Staff Summary Report

Development Review Commission Date: **04/10/07**

SUBJECT: Hold a public meeting for Development Plan Review for RESIDENCE INN BY MARRIOTT located at 125 East 5th Street.

DPR07004 – Development Plan Review including site plan, building elevations and landscape plan.

DRYWELL CALCULATIONS

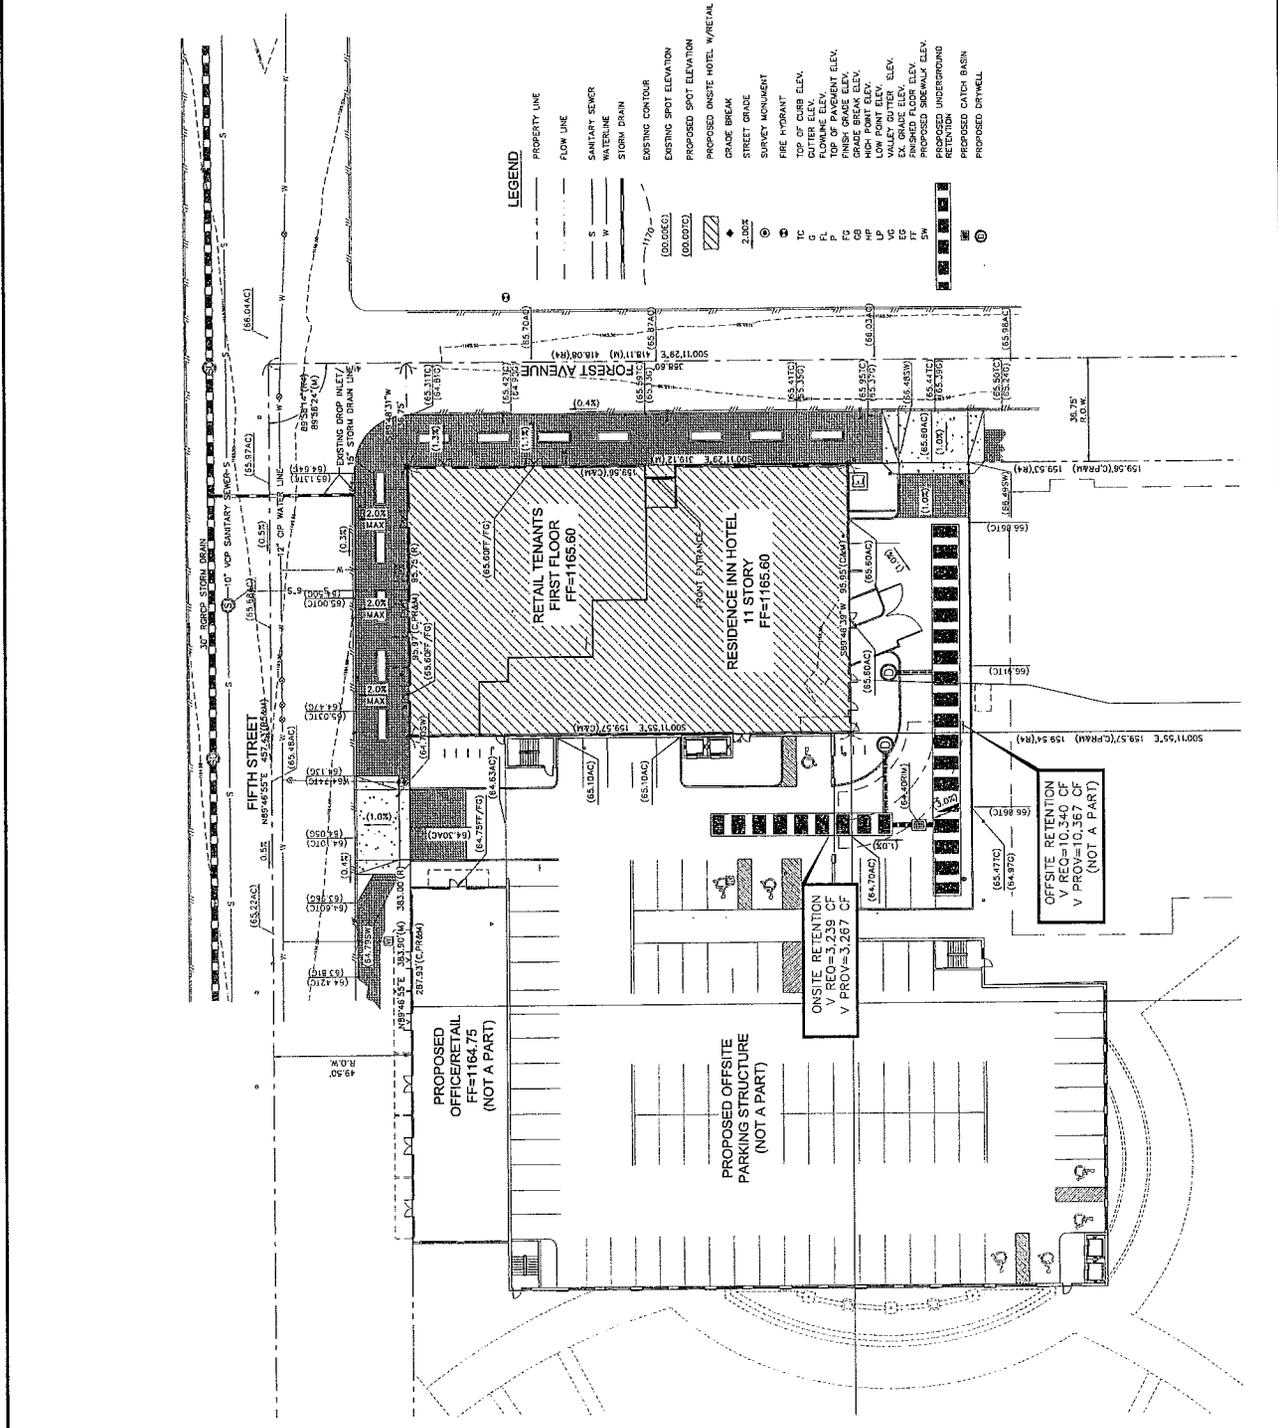
- 1) Following the suggestion made by Engineering staff in the Site Plan Review Public Works Department Comments, dated February 28, 2007, consider use of lawn at the southwest corner of the hotel as a filtration barrier for the drywells, allowing installation of single-chamber rather than dual chamber drywells. With reference to the same Engineering comments, investigate if one

drywell, rather than two, may be used at this location. See also **Landscape** Section below.
